Subject: PZR Safety Questions and Attachments

Enclosed document will be reference in an upcoming Calvert Cliffs inspection report.

From: Furio, Patricia S [Patricia.Furio@constellation.com]
Sent: Thursday, March 12, 2009 8:48 AM
To: Harry Balian
Cc: Kennedy, Silas
Subject: FW: PZR Safety Questions
Attachments: Document.pdf; BV02950 Body Inlet.JPG; Inlet Nozzle.JPG

Figure 1

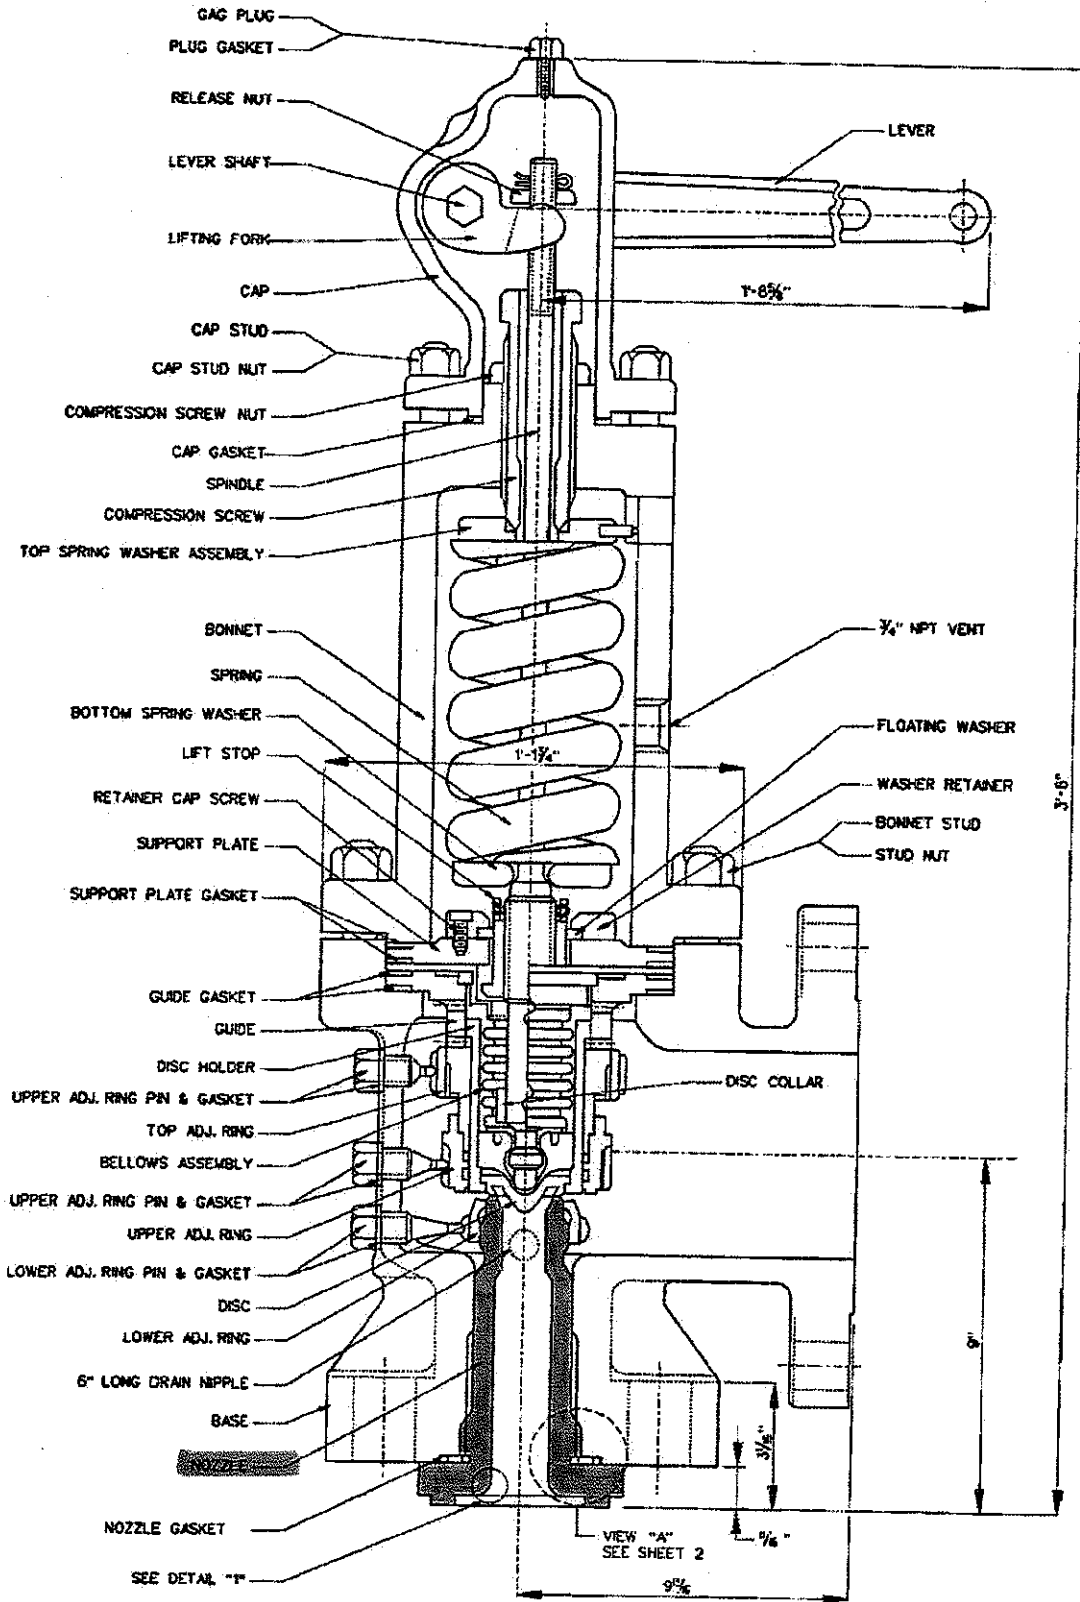
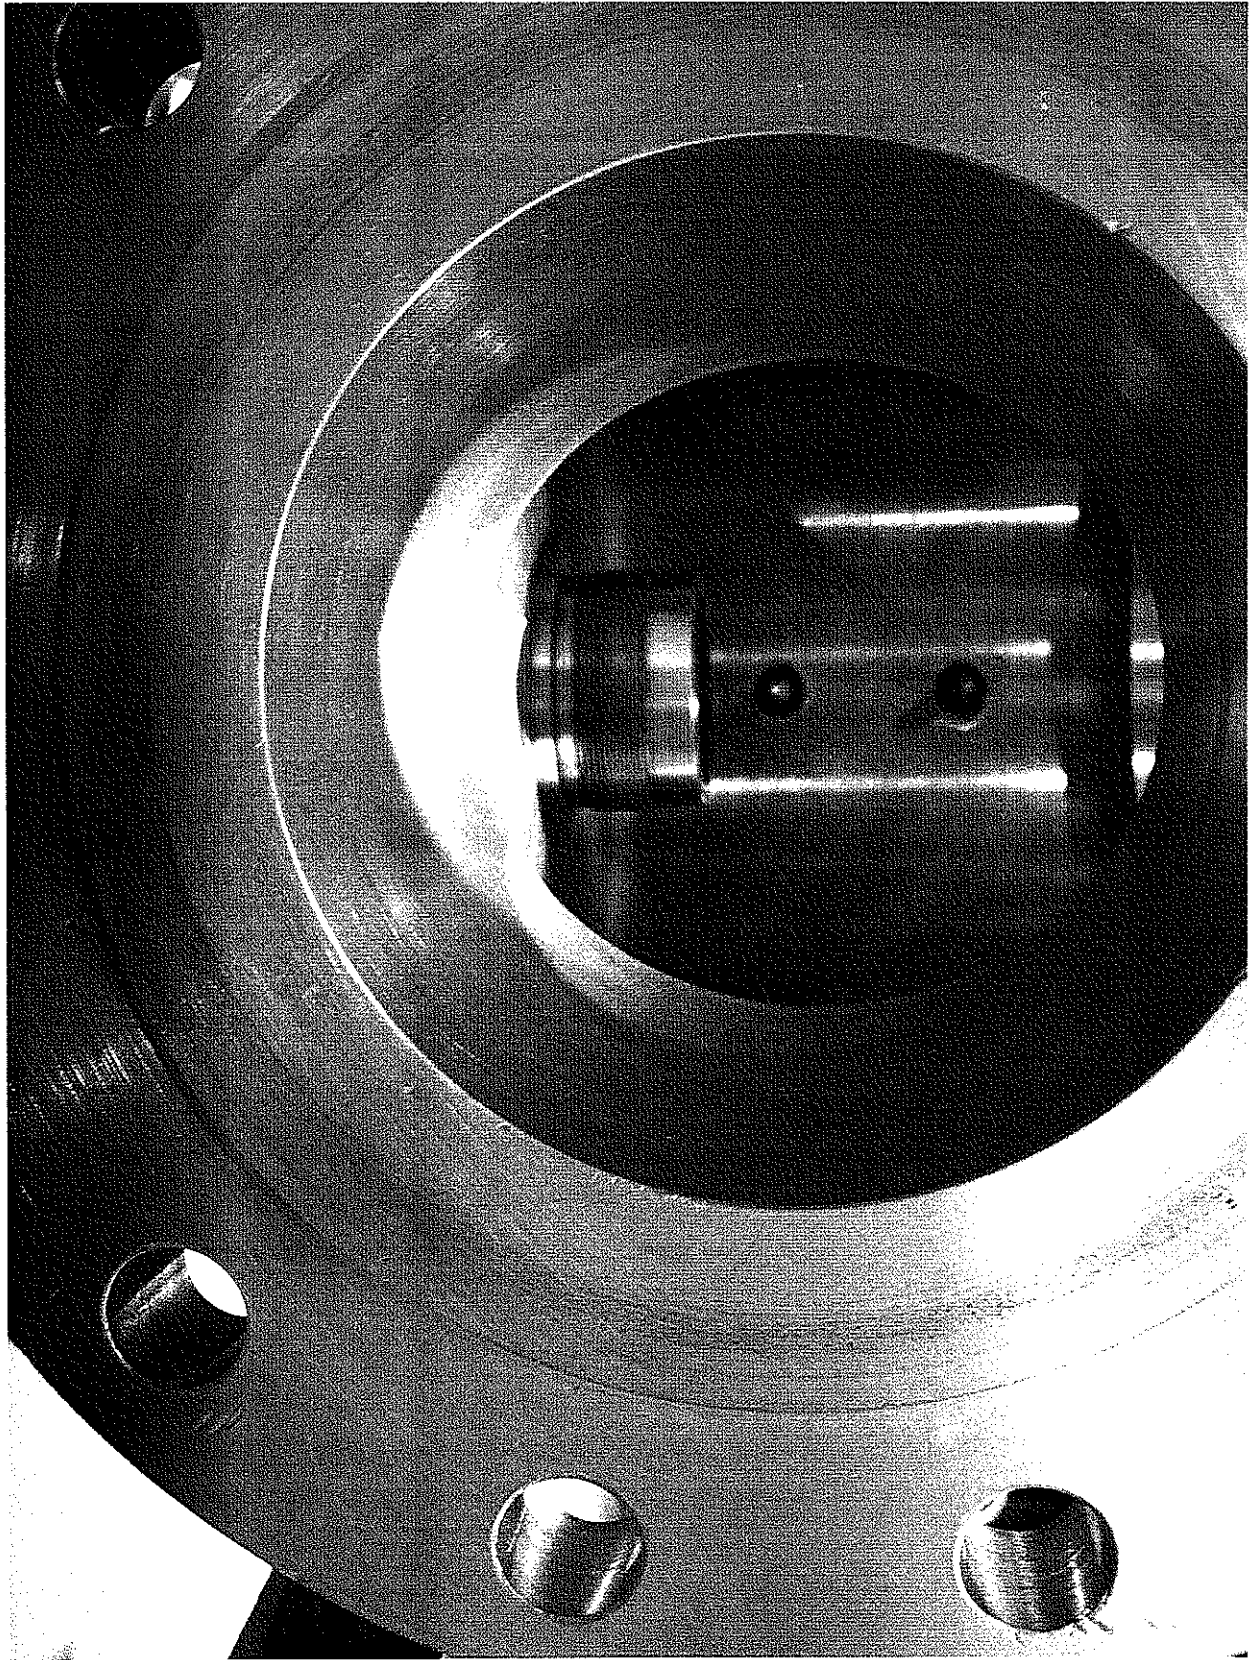
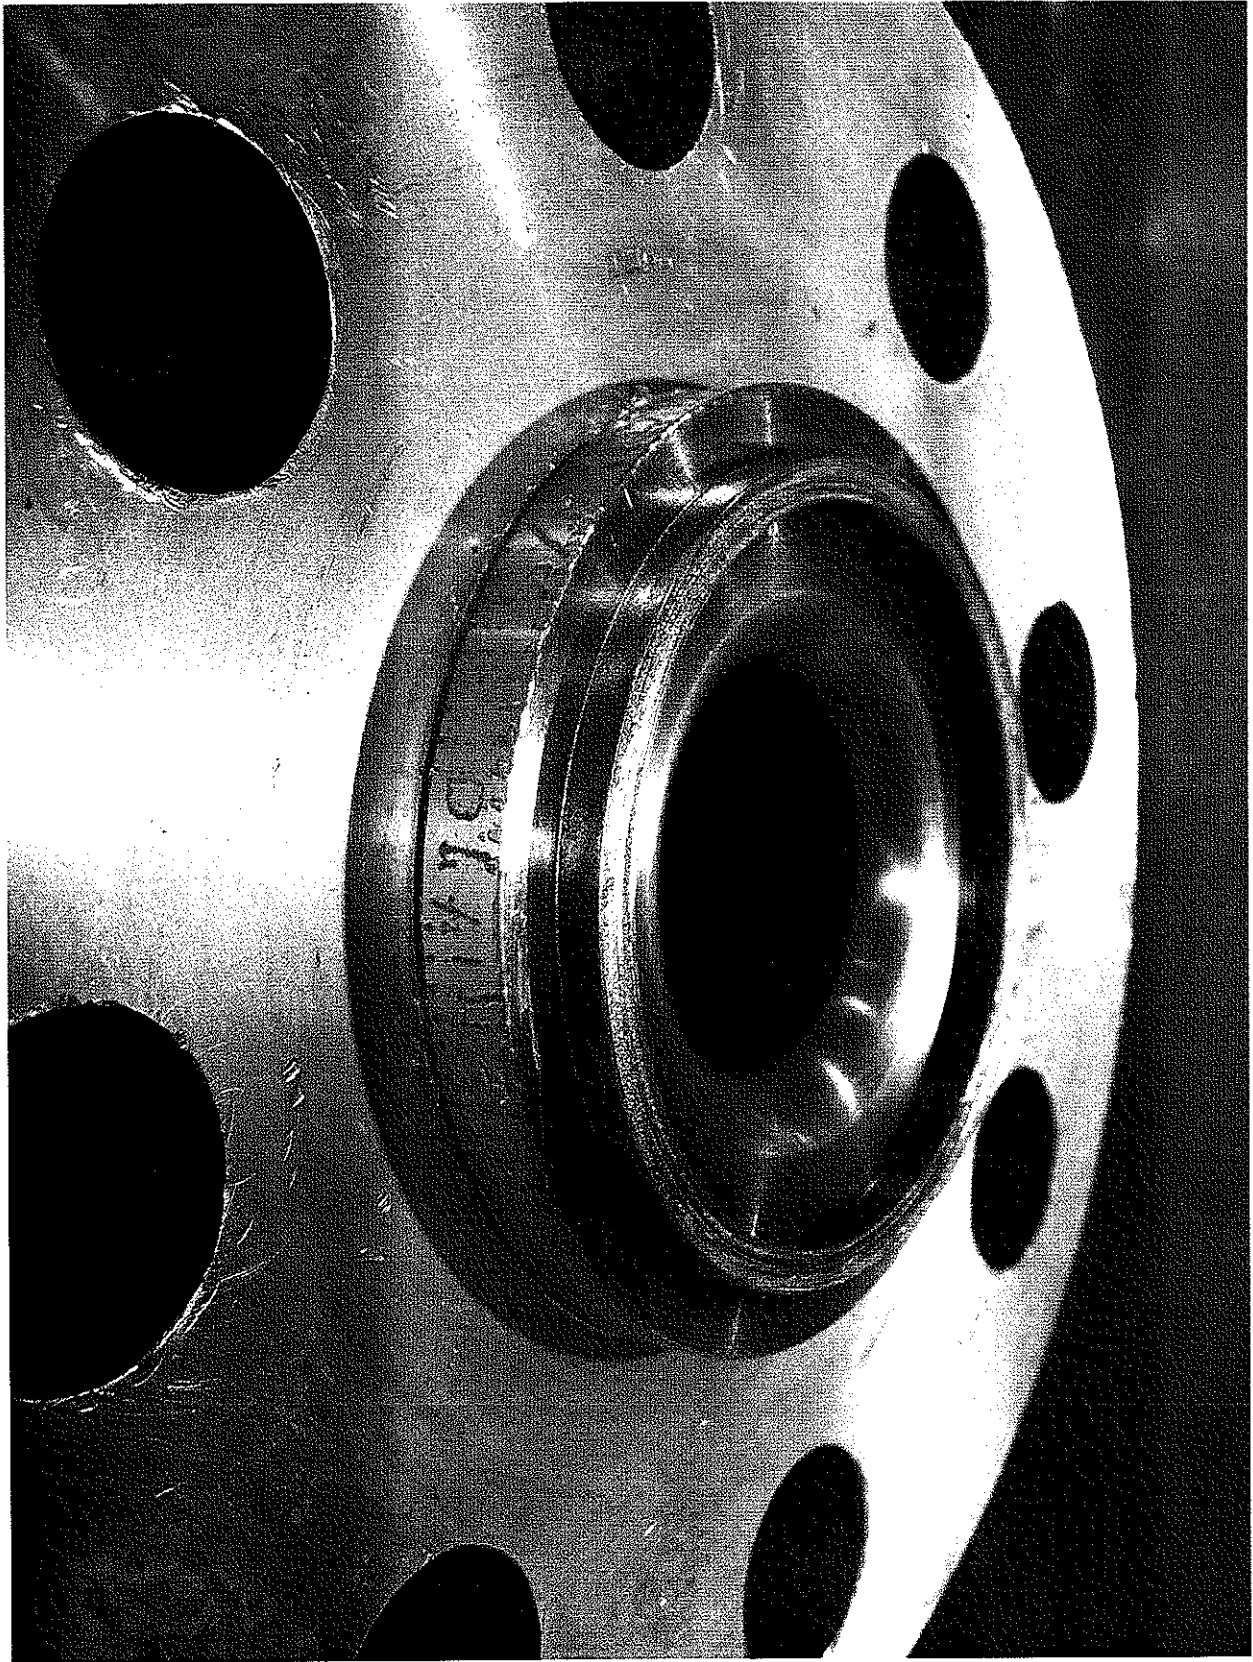
- a. what is inlet nozzle torque?

- c. is there a concern with low inlet nozzle torque? One of the evals indicates this is common.

See the attached drawing and two pictures. The sealing flange for the inlet to the valve is a nozzle that gets screwed into the body/base of the valve. It is torqued to 600 ft lbs on installation. That torque is checked and re-torqued if necessary during every rebuild.

The main concern would be leakage around the c-seal that is between the valve body and the inlet nozzle (This seal would only see pressure if the valve was open). Review of our test records show that it is not uncommon to find the nozzle torque less than 600 ft lbs.

KEVIN,
AS WITH ANY FASTENER, THREAD-TORQUE DEGRADES WITH HEATING AND COOLING CYCLES. IT IS NOT UNUSUAL TO FIND NOZZLES LOOSE. THE BODY-NOZZLE THREAD CONNECTION HOLDS THE NOZZLE IN PLACE UNTIL THE VALVE IS INSTALLED. WHEN THE VALVE IS INSTALLED, THE FLANGE OF THE NOZZLE IS SANDWICHED BETWEEN THE MATING FLANGES. A LOOSE NOZZLE DOES NOT AFFECT SET PRESSURE. HOWEVER, IT COULD AFFECT THE TIGHTNESS OF THE C-SEAL JOINT BETWEEN THE FACE OF THE BODY FLANGE AND THE BACKSIDE OF THE NOZZLE FLANGE. THIS MEANS THE JOINT COULD LEAK ON BACKPRESSURE TESTING. IN GENERAL DURING REFURBISHMENT IF THE NOZZLE IS FOUND LOOSE, DRESSER RECOMMENDS THAT THE NOZZLE BE RE-TORQUED. CAUTION! DO NOT USE THE TORQUE VALUES GIVEN ON PAGE 42 OF THE 31700 INSTALLATION AND MAINTENANCE MANUAL (DATED 10-28-78, REVISION 4, AND EARLIER). FOR THE 31739 PSV THE REVISED RECOMMENDED TORQUE IS 550-600 FT-LBS. THE HIGHER VALUES IN THE MANUAL MAY DISTORT THE FLANGE OF THE NOZZLE LEADING TO JOINT LEAKAGE. THERE IS NO RECOMMENDED PRACTICE FOR PREVENTING DEGRADATION OF THE NOZZLE TORQUE.
